Project Location:	0 Mandela Parkway. The vacant parcel is located across from the neighboring property at 3650 Mandela Parkway and next to Beach Street and Target store.
Assessor's Parcel No:	007 061701405
Development Proposal:	To construct a six-story building "Mandela Hotel" consisting of 220 rooms measuring approximately 142,813 square feet of floor area with two-levels of underground parking garage and a small open parking area totaling 166 parking spaces.
Project Applicant / Phone Number:	Joanne Park, lead architect for Architectural Dimensions / (510) 463-8300
Hotel Operators:	Tulsee Nathu & Payal Nathu
Property Owner:	State of California
Case File Number:	PLN16394
Planning Permits Required:	<ol style="list-style-type: none"> 1) Major Conditional Use Permit for non-residential projects with more than 25,000 square feet of floor area; 2) Minor Conditional Use Permits for transient habitation (Hotels) and non-residential tandem parking; 3) Regular Design Review for new building construction; and 4) Minor Variance for front yard setback reduction.

CITY OF OAKLAND PLANNING COMMISSION

Case File: PLN16394

Date: March 20, 2018
To: Mike Rivera, Project Case Planner
From: Sharon Wr

Figure 4

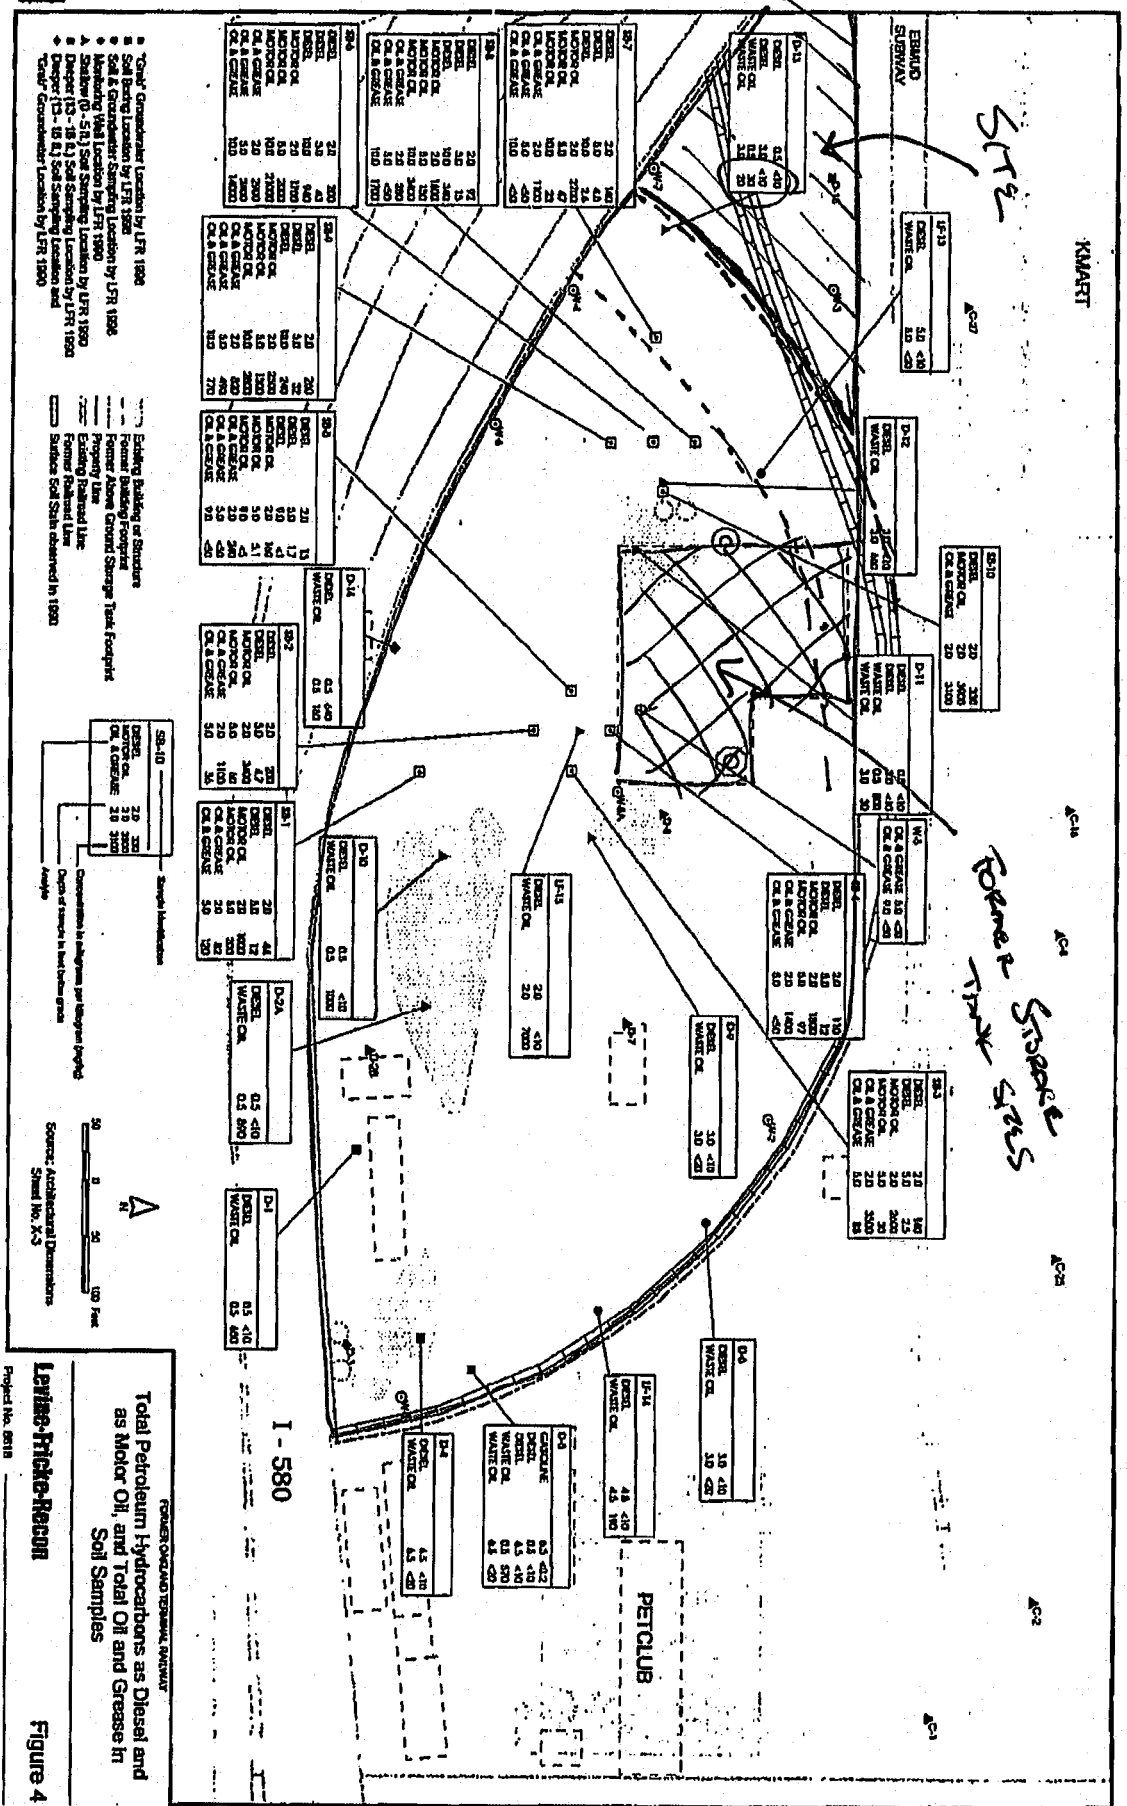
- Attachment 1. Figure 4: Total Petroleum Hydrocarbons as Diesel and Motor Oil, and Total Oil and Grease in Soil Samples. Source: Levine Fricke Recon. Notations by Lamphier-Gregory.
- Attachment 2. Figure 1: Site Location Map. Source: East Bay Municipal Utility District.
- Attachment 3. EDR Detail Map for Mandela/West Grand Opportunity Area.

Figure 1

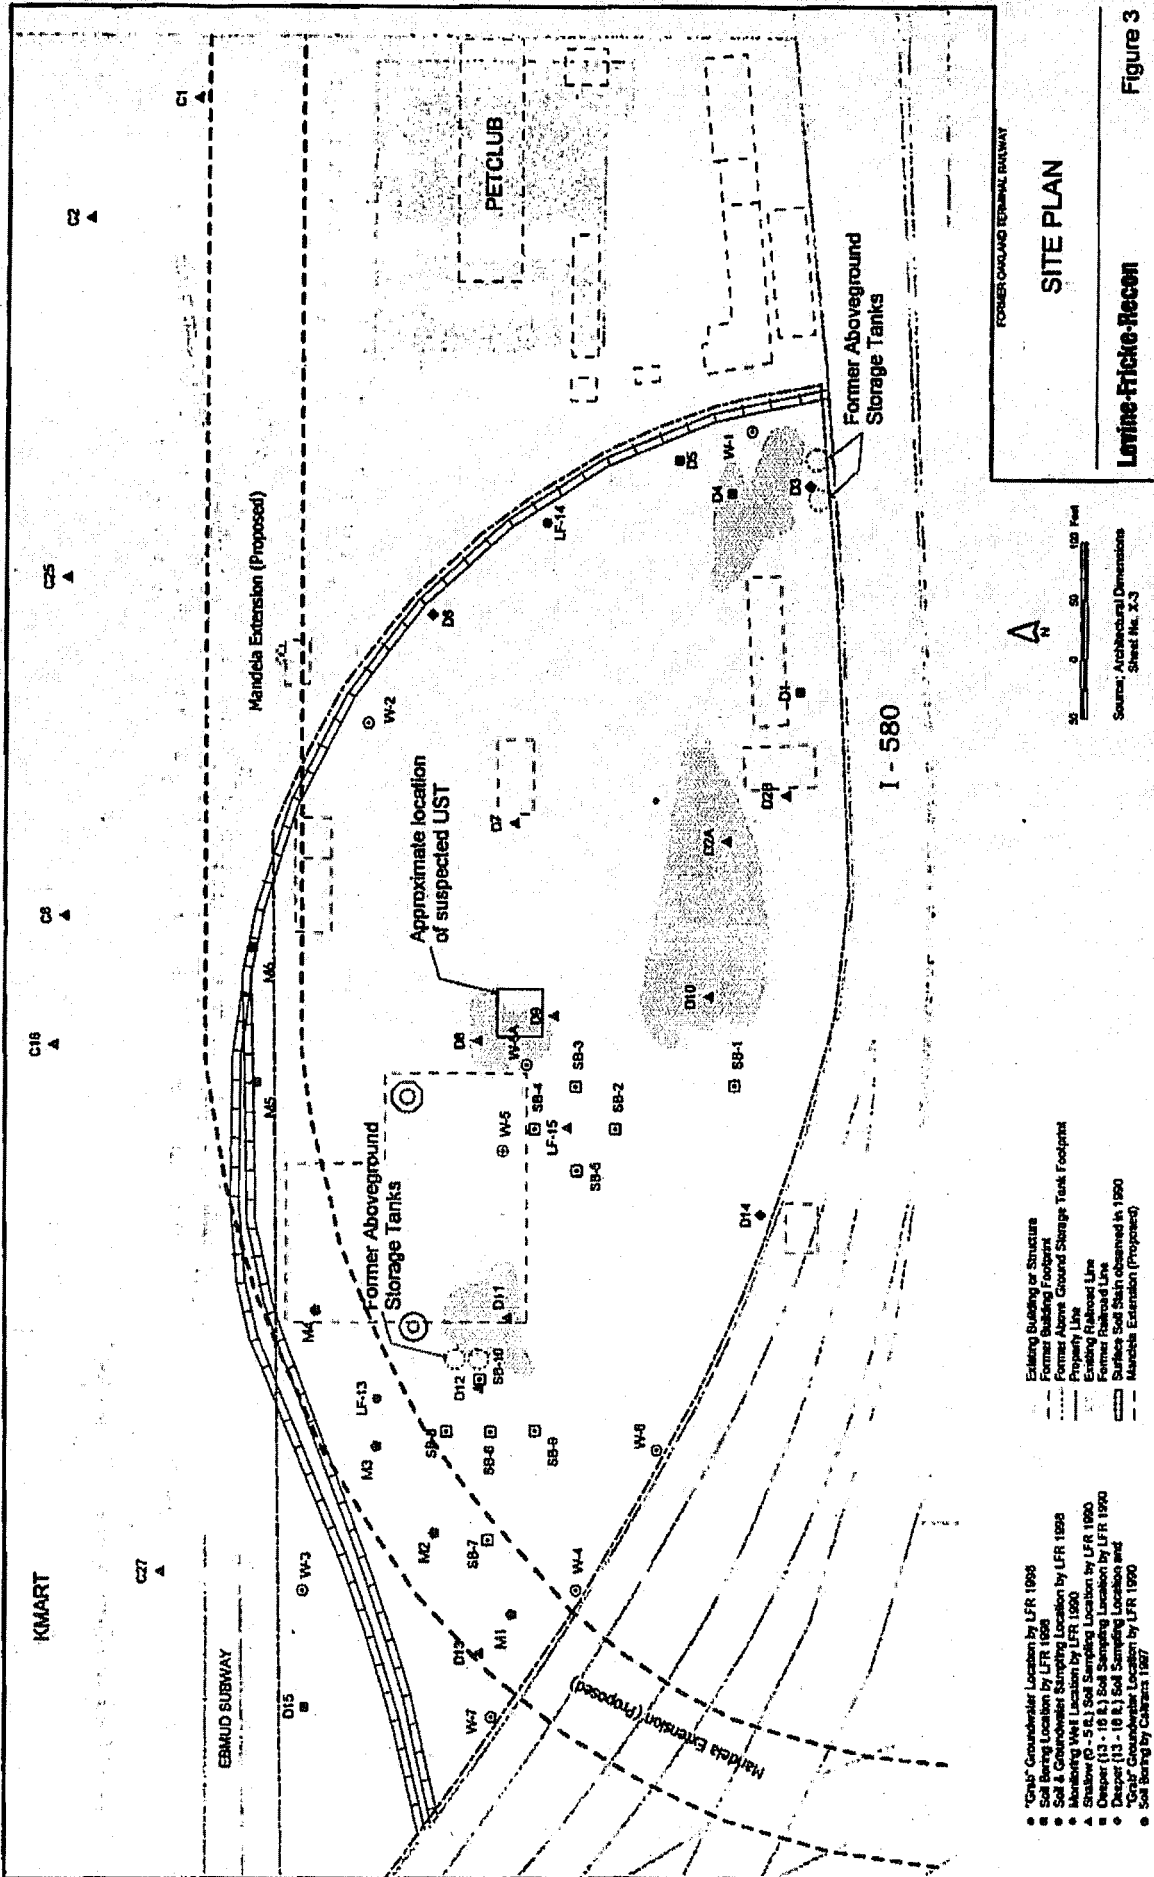
The attached “Site Location Map,” prepared in 1999 by Levine-Fricke-Recon, comes from the Alameda County Environmental Health Department’s case file for the OTR Site. The shaded area on the map clearly indicates that the parcel where the new hotel is proposed is part of the OTR Site. Alameda County Parcel Maps 2045 and 7572, as well as four more detailed maps from Levine-Fricke-Recon, all of which are also attached to this letter, show this even more clearly. On Parcel Map 7572, the triangular parcel to the west of the future Nelson Mandela Parkway and marked “State of California Dept. of Transportation” is the proposed location of the Mandela Hotel. As shown on Parcel Map 2045, this triangle of land was part of the OTR property before it was transferred to the State of California.

Department of Environmental Health about cleanup efforts performed on the Mandela Hotel site is because no cleanup efforts were required on this portion of the OTR property pursuant to the Workplan for Soil Excavation and Groundwater Monitoring as approved by the RWQCB.

Figure 5
Map of Proposed Soil Reuse Sites
Castroville Project No. 04-14355A
I-580 KP 74.5

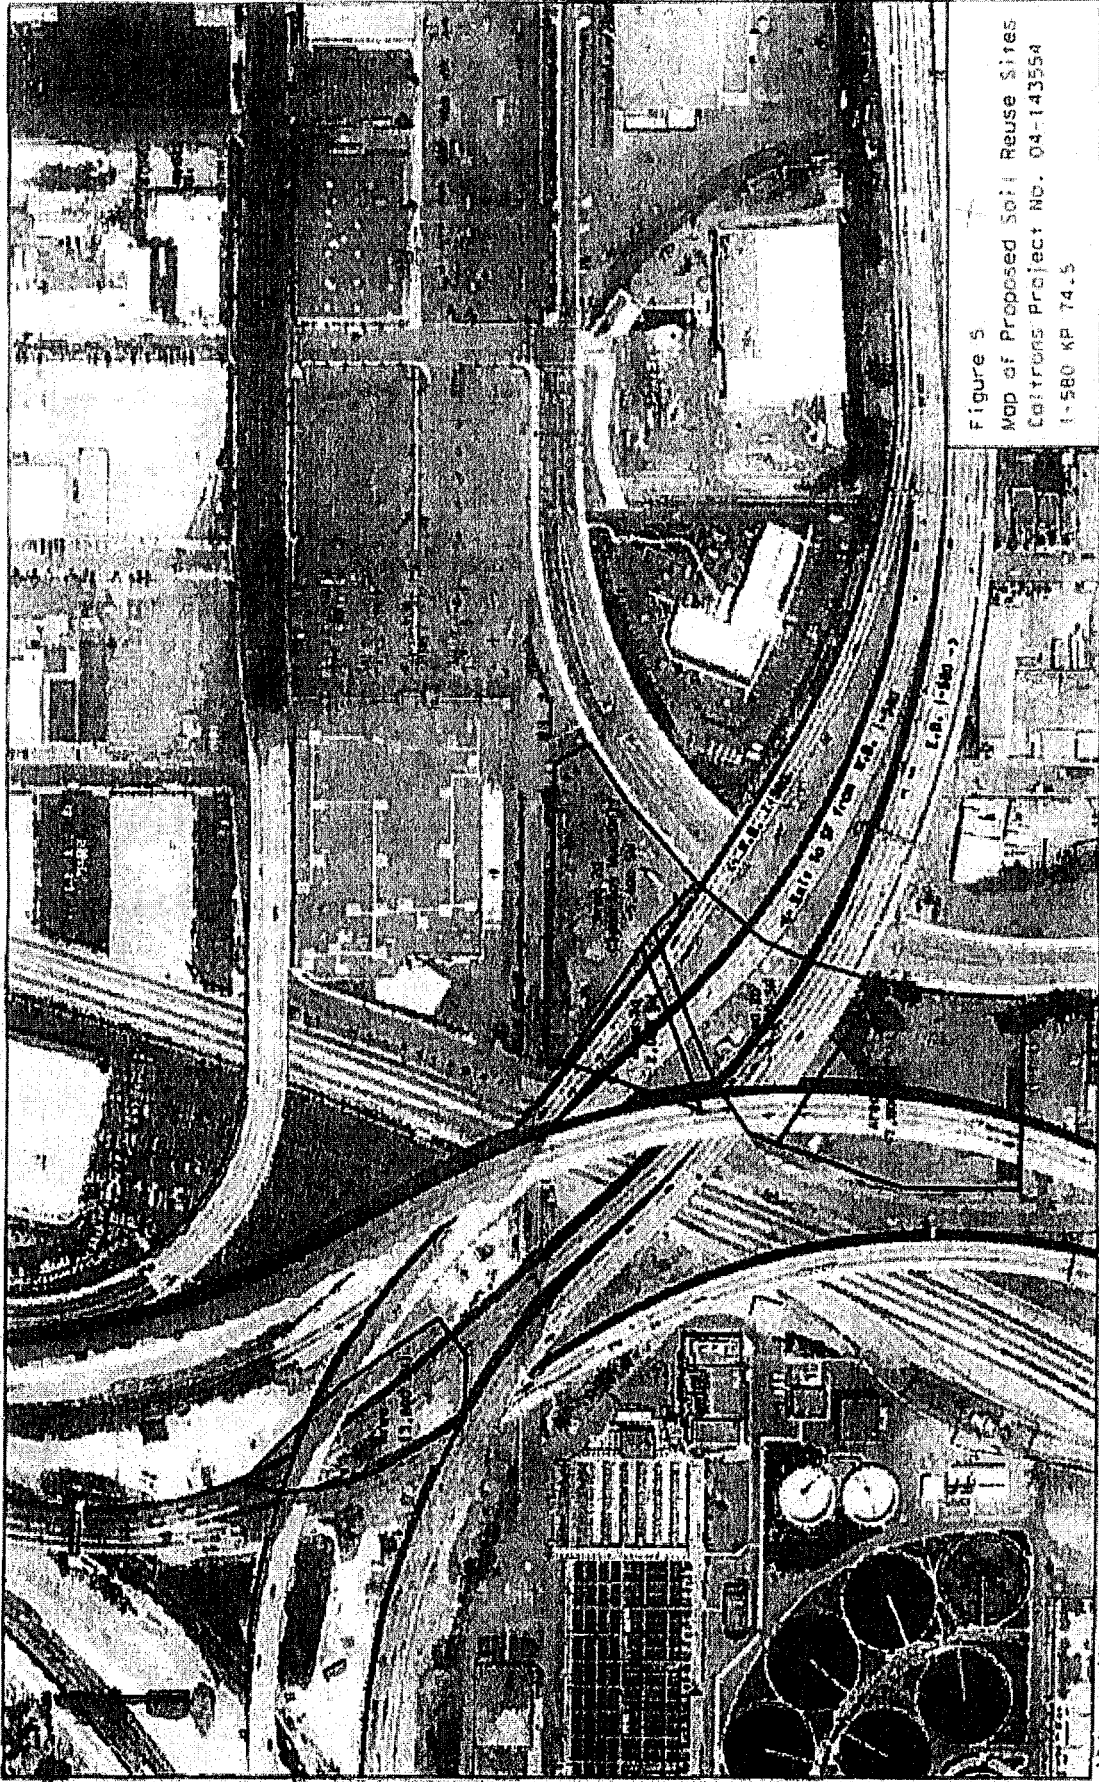
site.”² The Mandela Hotel project site is immediately adjacent to the I-580 viaduct, immediately to the west of where it crosses over Mandela Parkway. The retrofit of the SFOBB Distribution Structure required the relocation of an EBMUD pipe known as the Adeline Interceptor, and the attached maps labeled “Figure 2 EBMUD Adeline Interceptor Relocation Project - Location Map 1” and “Figure 5 Map of Proposed Soil Reuse Sites” show that the proposed hotel parcel is part of this project site.

from Caltrans to DTSC indicates that Caltrans believed that all of the contaminated material could be safely reused on or near the site instead of being disposed offsite, provided that an appropriate cap is placed over the soil. DTSC's response to Caltrans in September 2006 indicated that DTSC might approve on-site reuse and capping of the contaminated soil, provided that Caltrans enter into a land use covenant which restricts the use of the property, and that an Operation and Maintenance Plan for inspection, maintenance, and repair of the cap be prepared and implemented under DTSC oversight and approval. The September 2006 letter concluded with the request to "Please inform DTSC if Caltrans intends to reuse the contaminated soil onsite and proceed with submittal of the cap design. Otherwise, proceed with its disposal at a permitted, off-site disposal facility."
